DART SERVICE INSTRUCTION

TO AMEND INSTALLATION INSTRUCTIONS IIN-D350-822 REV. H AND INSTRUCTIONS FOR
CONTINUED AIRWORTHINESS ICA-D350-822 REV. 6 OR LATER APPROVED REVISION

The purpose of this Service Instruction is to facilitate the replacement of the QD3072-46 Receptacles that are installed on the QB21308 Assembly Screen manufactured by Pall Aerospace as part of the D350-822-011/-013 PA100 PUREair System with the DSI 9815-011 Replacement Receptacle kit. The intent of this DSI has been incorporated into D350-822-011 at CHG 005 and D350-822-013 at CHG 003.

A	NEW ISSUE	VS	18.12.10
REV.	DESCRIPTION	BY	DATE
DESIGN	VS	DART AEROSPACE LTD HAWKESBURY, ONTARIO, CANADA	
DRAWN	VS		
CHECKED	WK	DRAWING NO.	REV. A
MFG. APPR.	N/A	DSI 9815	SHEET 1 OF 4
APPROVED	VS	TITLE	SCALE
DE APPR.	DS	REPLACEMENT RECEPTACLE	NTS
DATE	18.12.10	COPYRIGHT © 2018 BY DART AEROSPACE LTD. THIS DOCUMENT IS PRIVATE AND CONFIDENTIAL AND IS SUPPLIED ON THE EXPRESS CONDITION THAT IT IS NOT TO BE USED FOR ANY PURPOSE OR COPIED OR COMMUNICATED TO ANY OTHER PERSON WITHOUT WRITTEN PERMISSION FROM DART AEROSPACE LTD.

Figure 1 - QB21308 Assembly Screen

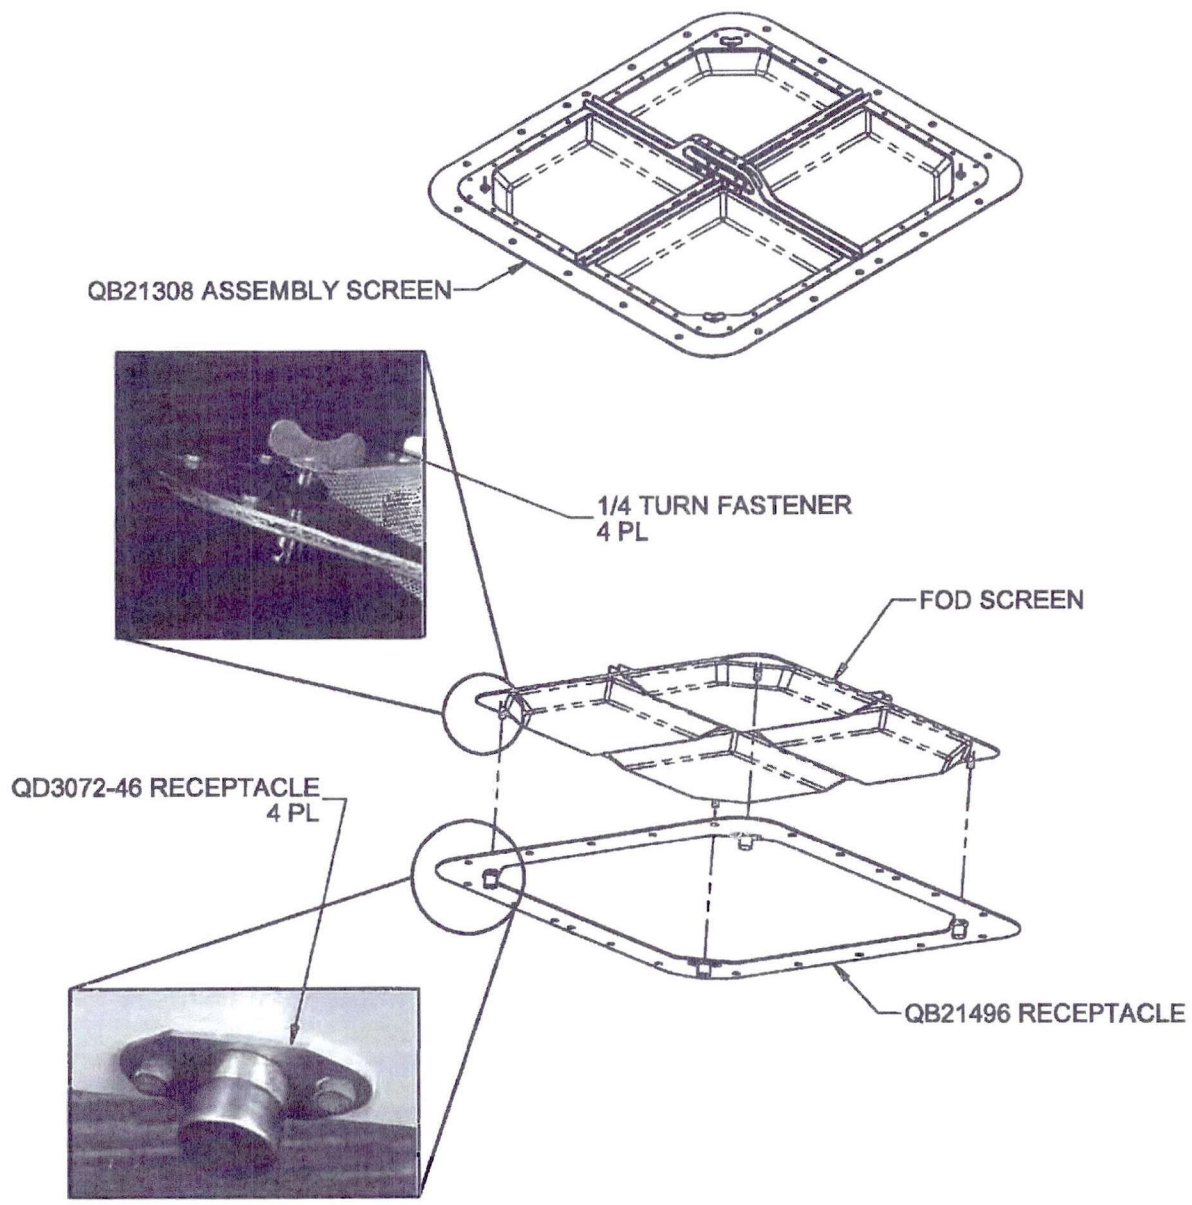
- 2.1.3 Separate the FOD screen from the QB21496 Receptacle by turning the 1/4 turn fasteners and lift the FOD screen per Figure 1.
- 2.1.4 Drill out the retaining rivets and remove qty(4) QD3072-46 Receptacles from the QB21496 Receptacle. Remove any adhesive residue.

- 2.1.8 Remove qty(4) 1/4 Turn Fasteners from the FOD Screen per Figure 1.
- 2.1.9 Reinstall the FOD screen on the QB21496 Receptacle using qty(4) AN4-5A bolts and qty(4) NAS1149D0432J Washers per Figure 2. Torque bolts to 50-70 in-lb (5.6-7.9 N-m).

Figure 2 - DSI 9815-011 Replacement Receptacle Kit

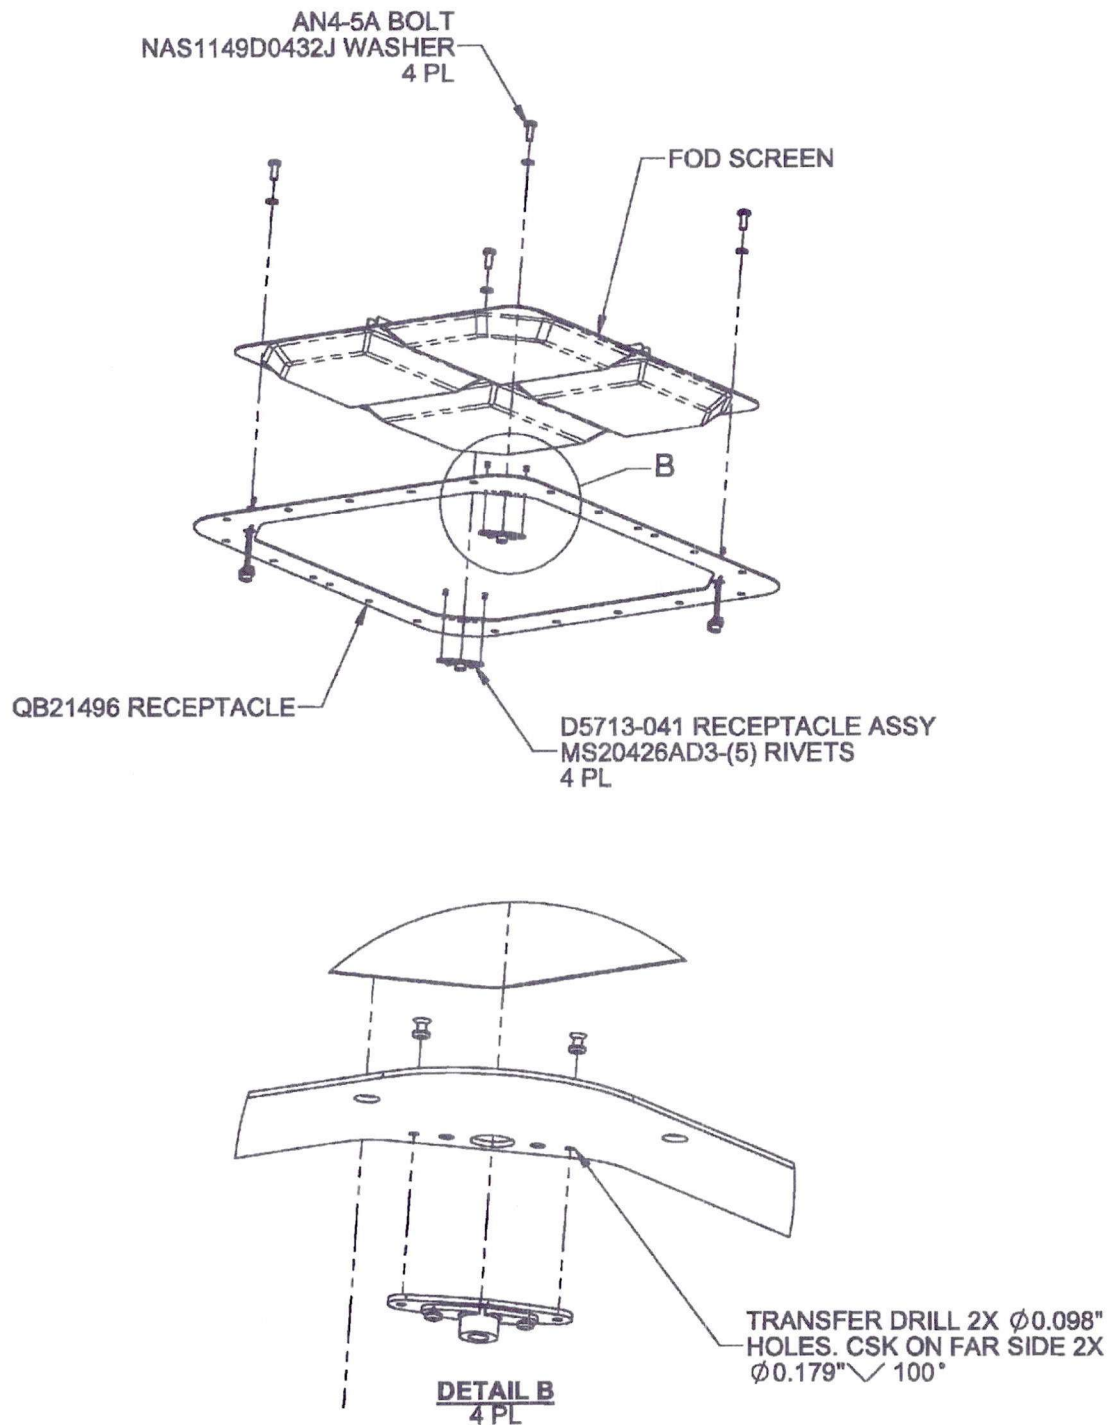
- 2.1.5 Position the qty(4) D5713-041 Receptacle Assy in the location shown in Figure 2. Transfer drill 2x $\varnothing 0.098$ " holes with CSK $\varnothing 0.179$ " $\angle 100^\circ$ on the top side from the D5713-041 Receptacle Assy to the QB21496 Receptacle. Touch up holes with Alodine 1200 per MIL-C-5541.

- 2.1.6 Mask nutplate holes and touch up the affected areas with prime and paint per ICA-D350-822.
- 2.1.7 Install qty(4) D5713-041 Receptacle Assy with qty(2) MS20426AD3-(5) Rivets per Figure 2.
NOTE: Although not generally necessary, it is acceptable to use longer or shorter MS20426AD3-X Rivets

2.3.2 Install the FOD Screen with qty(4) AN4-5A bolts and qty(4) NAS1149D0432J Washers per Figure 2.
